Rezoning Transportation Analysis

Petition Number: 2022-147

From: Jake Carpenter, PE

Reviewer:

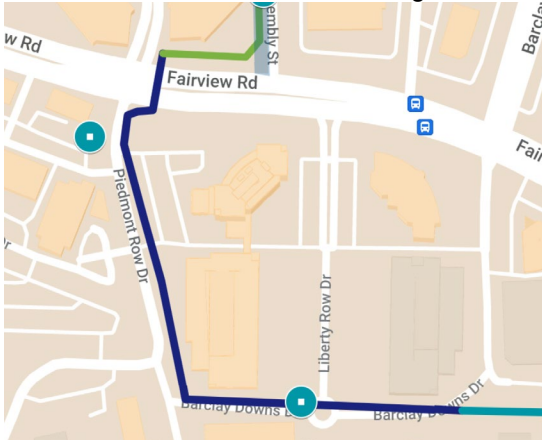
- Outstanding Comment from 1-25-23** Revise site plan and conditional note(s) to commit to dedicate 63 feet of right-of-way from the Fairview Road centerline. The site plan shall label and dimension the right-of-way from the road centerline.

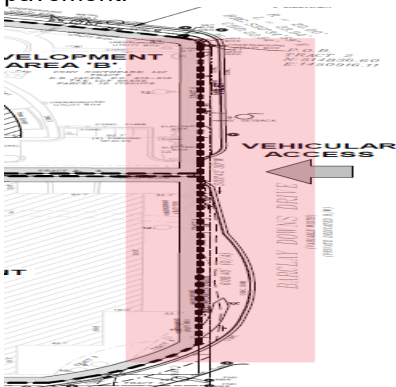
4. ~~Revise site plan and conditional note(s) to commit to constructing The LOOP standard 12 foot sidewalk along the portion of the property frontage where The LOOP is designated to be constructed. As shown below, The LOOP path is along the southern portion of Barclay, goes North on Piedmont Row Drive, and crosses Fairview at the existing crosswalk.~~

5. ~~Revise site plan and conditional note(s) to commit to construct an 8-foot planting strip, and 12-foot Multi-Use Path on Fairview Road to support the City Council adopted Charlotte Streets map, and to meet the Council adopted Charlotte BIKES Policy. Multi-use paths maintained by the City shall meet ADA/PROWAG requirements. The site plan shall label and dimension both items from the back of curb and gutter or edge of pavement.~~

Clarifying Comment 2-22-23: ~~Update conditional note V.e. under Transportation to state “Sidewalks may meander to preserve existing conditions where approved by CDOT and Urban Forestry.~~

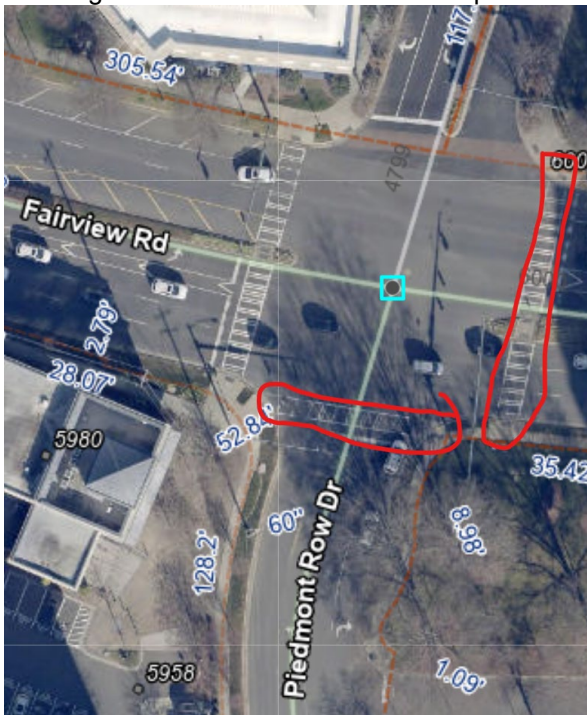
8. ~~Per coordination and request of The LOOP project team: revise site plan and conditional note(s) to commit to install LOOP branded furniture within property boundary that includes 2 benches and a bike rack near intersection of Piedmont and Fairview within Development Area "A". The LOOP project team has already purchased the furniture, the request is for the developer to install it.~~
